SERVICE BULLETIN

No. 202

Piper Aircraft Corporation

SUBJECT: Inspection of Comanche Exhaust System

SKETCH "A"

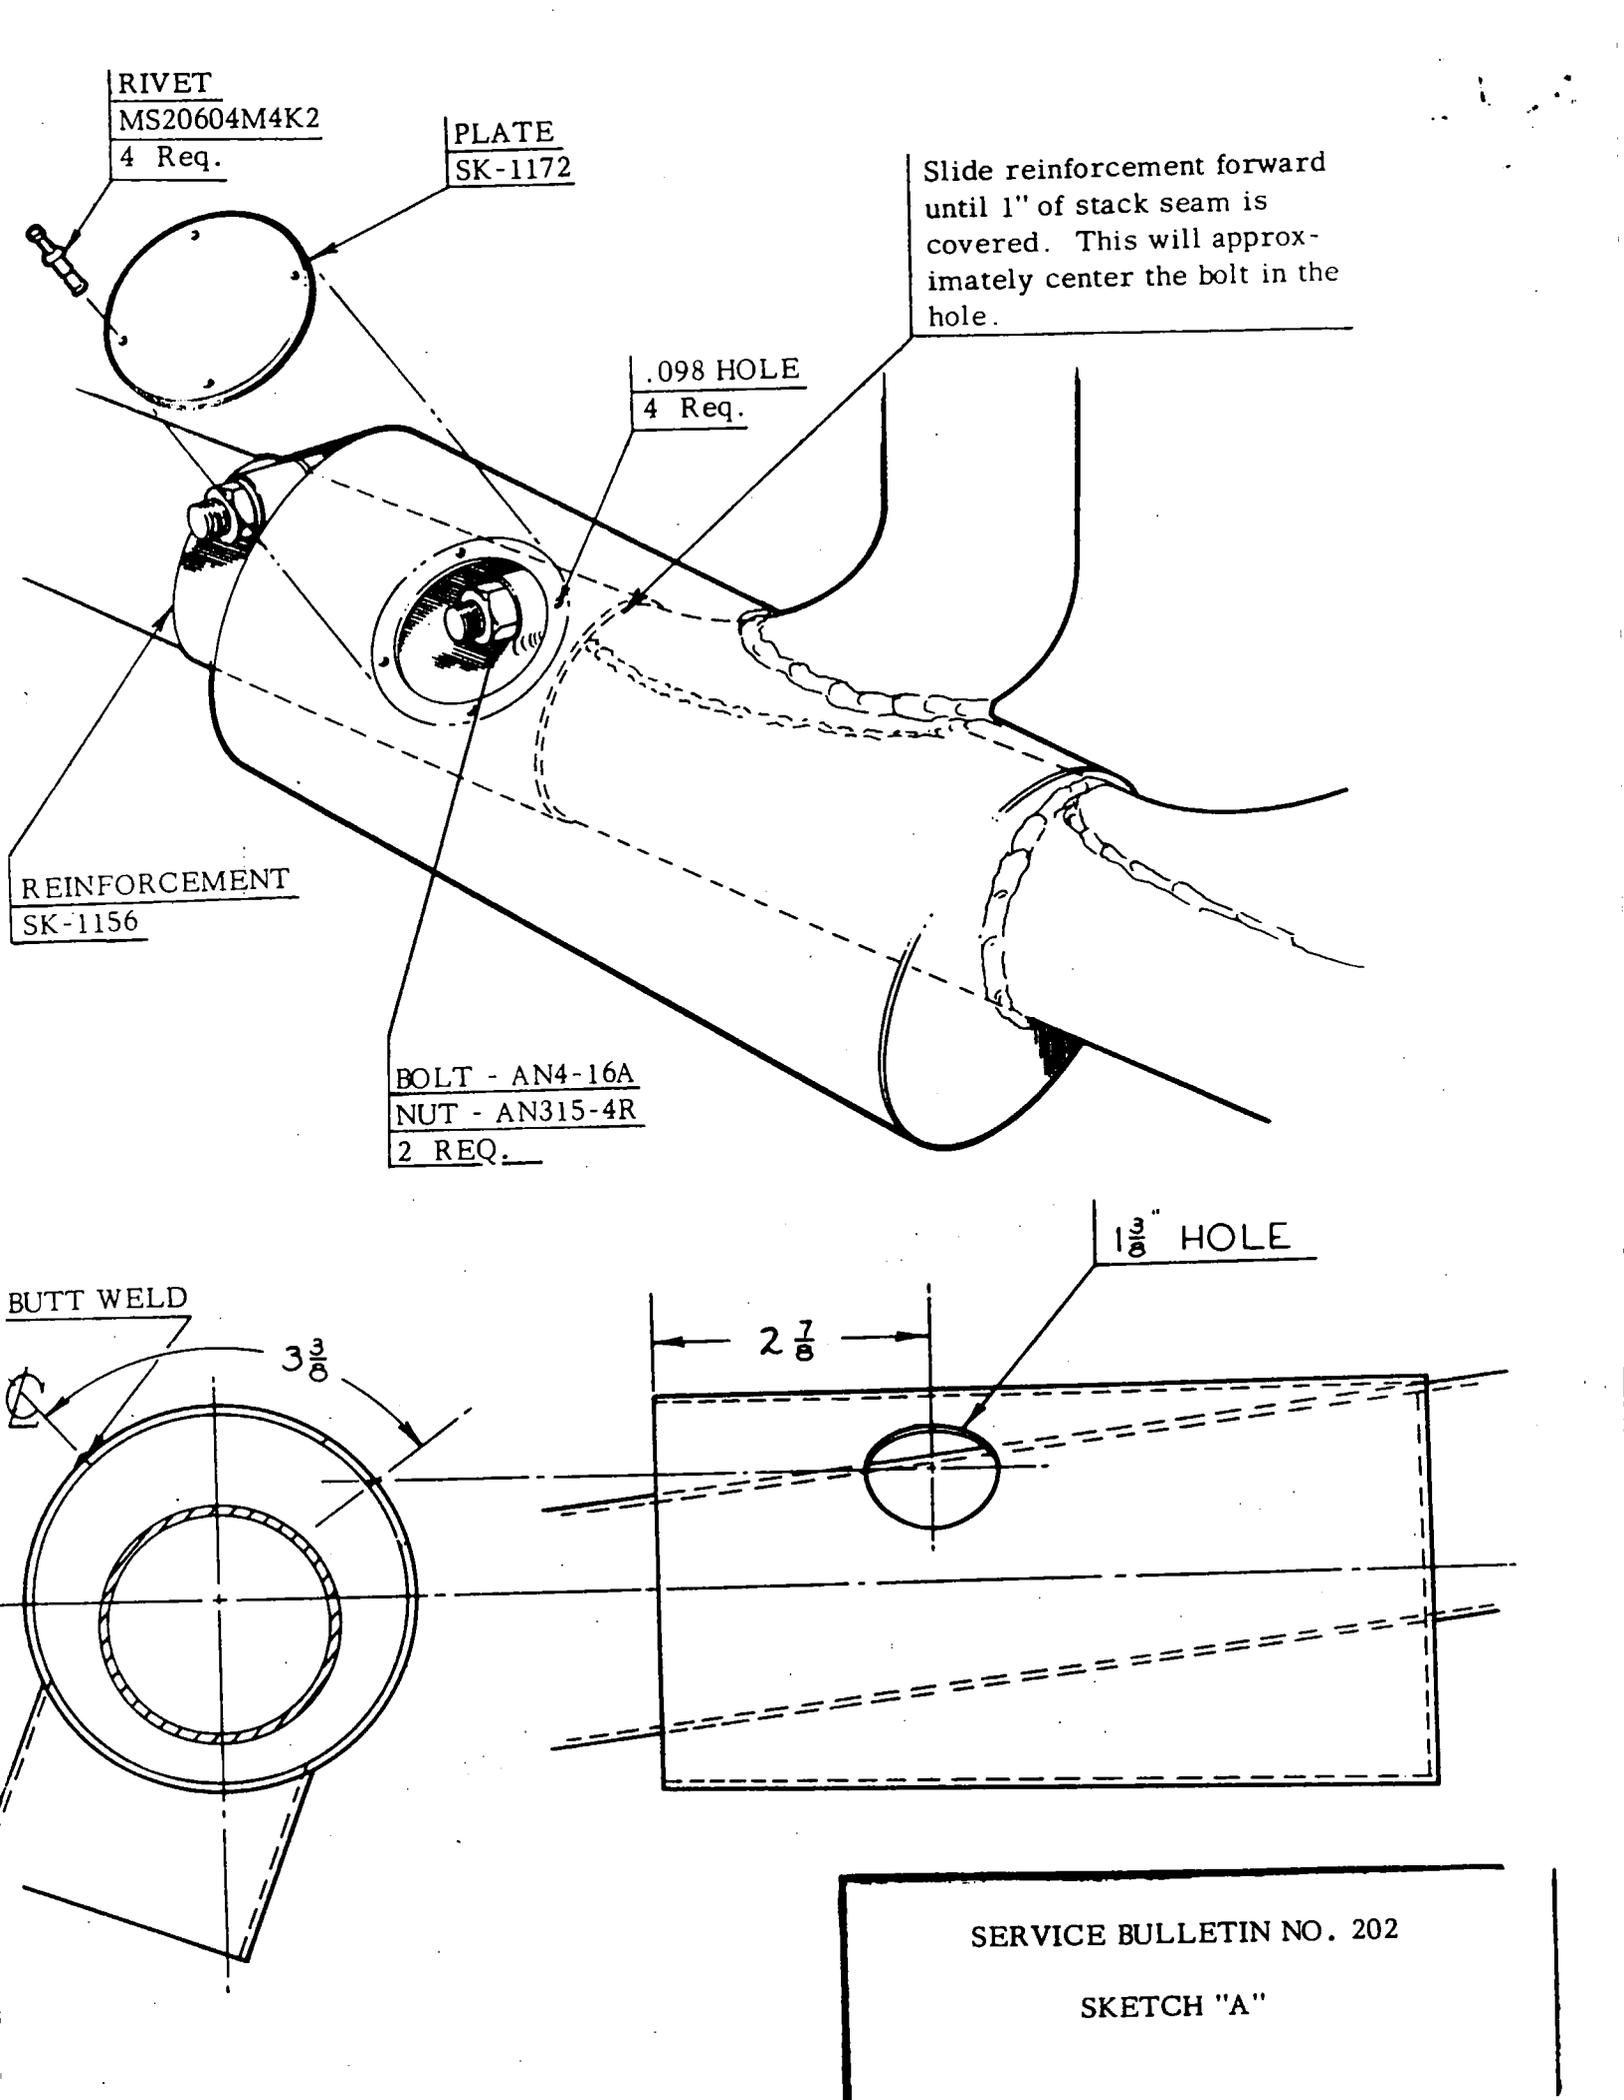
Field service reports indicate that cracks have been appearing in the engine exhaust stack assembly, right side - Part number 21664-03. It is requested these stacks be inspected for cracks or other indications of deterioration in the following manner:

1. Remove or loosen the shroud assembly.
2. Inspect the exhaust stack assembly for any indication of cracks or deterioration. A thorough examination of the area where the rear cylinder exhaust stack is welded to the exhaust stack assembly should be made. This assembly must be replaced immediately if this condition is noted.
3. Exhaust stacks that have a reinforcing plate welded to the stack in the area where Kit No. 754 396 is to be installed will not be affected by this Bulletin.
4. Stacks that do not have the reinforcement plate but are found to be in satisfactory condition shall be inspected each 50 hours of operation until reinforced with Kit No. 754 396. Installation of Kit No. 754 396 must be accomplished prior to but not later than the next 100 hour inspection. Refer to sketch on the reverse side and attached instruction sheet.

Slide reinforcement forward
until 1" of stack seam is
covered. This will approx-
imately center the bolt in the
hole.

3. Locate, mark and drill holes in stationary part of air shroud as per Sketch "A".
4. Make sure all metal filings are cleaned out of shroud before reassembly of air shroud.

5. Install reinforcement on exhaust stack. Slide reinforcement forward until bolt is centered in hole cut in air shroud. This should move the reinforcement far enough forward to cover 1" of exhaust stack weld.

6. Torque nuts to 120 inch lbs. on the initial installation of the reinforcement. Run up the engine on the ground at 1500 RPM for five minutes. After ground run up torque nuts to 60 inch lbs.

7. Reassemble shroud, hook up air ducts and make another ground run up for five minutes at 1500 RPM. Again check nut torque value for 60 inch lbs. This procedure allows the reinforcement to seat on the stack assembly. Stake bolt threads to safety nuts.

8. After final torque check install repair plate Part No. SK-1172 as per Sketch "A".
